APPLICATION NO.	FILING DATE	FIRST NAMED INVENTOR	ATTORNEY DOCKET NO.	CONFIRMATION NO.
10/046,012	01/11/2002	Robert A. Cann		5208

# Office Action Summary

**DETAILED ACTION*****Drawings***

Claim 2 is rejected under 35 U.S.C. 102(b) as being anticipated by Morgan (USPN 3050761).

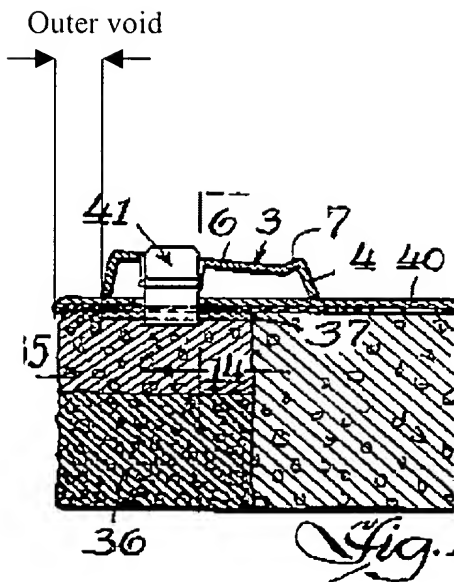
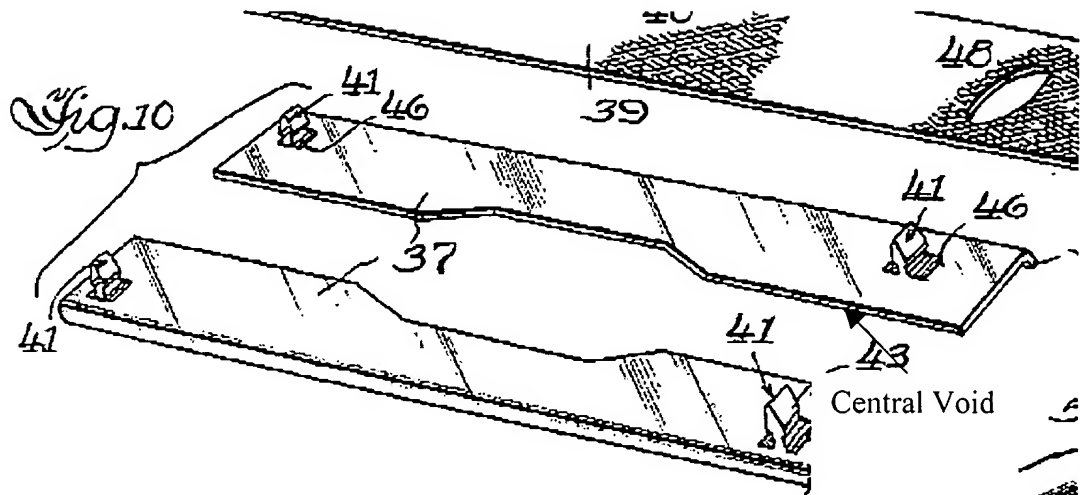
Morgan teaches a latch to secure a mop head to a handle comprising a pair of opposed tabs (41). The upper and lower portions of the tabs correspond to apertures (53) in the mop head. The central portion of the tab ramps (43) outward such that the dimensions between the opposed tab ramps is larger than the aperture opening. The tabs are centrally located on a beam (37) that extends a short distance beyond either end of the tab until attaching to a backing plate (39, 49). There is a central void between the beams and an outer void further defining a space outside each beam (see figures below).

Claim 2 is rejected under 35 U.S.C. 102(b) as being anticipated by Empire Brush Prior Art.

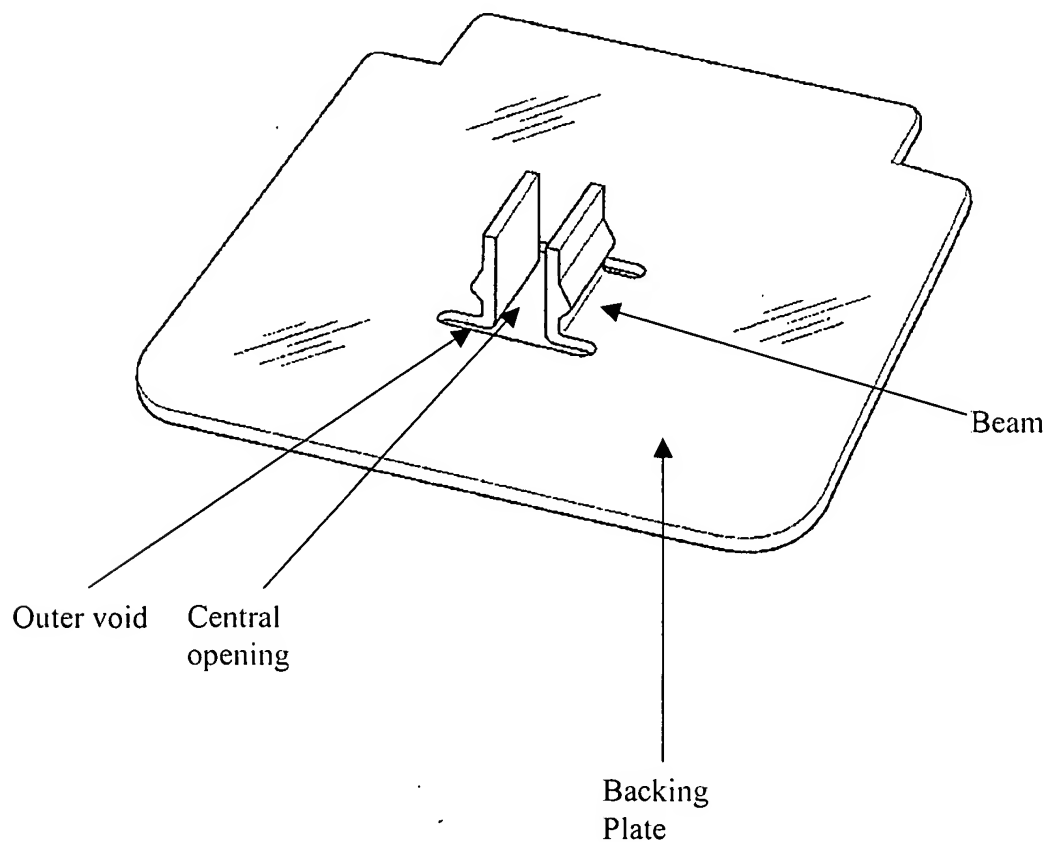
Empire Brush teaches a latch to secure a mop head to a handle comprising a pair of opposed tabs. The upper and lower portions of the tabs correspond to apertures in the mop head. The central portion of the tab ramps outward such that the dimensions between the opposed tab ramps is larger than the aperture opening. The tabs are centrally located on a beam that extends a short distance beyond either end of the tab until it attaches to a backing plate. There is a central void defining a space between the beams and an outer void defining a space outside each beam (see figure below).
